Draft Minutes of the Vth Meeting of the
Technical Committee Held on 22-8-2000.

**DELHI DEVELOPMENT AUTHORITY
DEVELOPMENT CONTROL WING**

No.F.1(11)/2000/MP

ZONAL PLAN SECTION

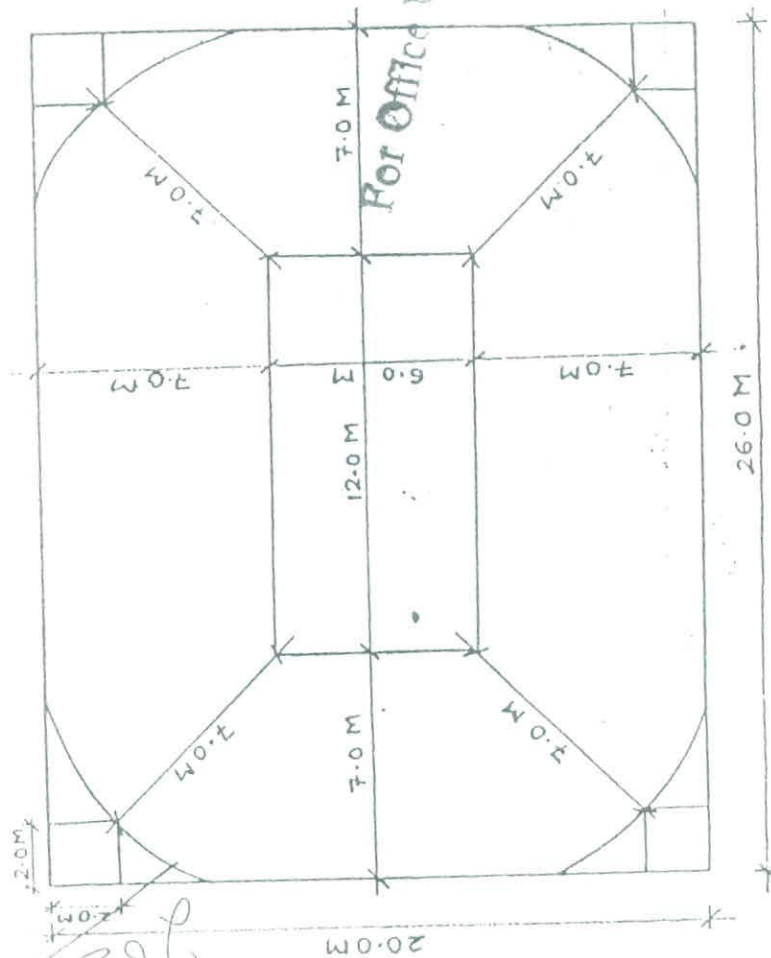
- iii) **Fire Safety Norms:** Consequent to the discussions the modified guidelines for fire safety were received from Deputy Chief Fire Officer. It is recommended that the norms received from Deputy Chief Fire Officer be considered, while identifying the size. (Annexure 'C').
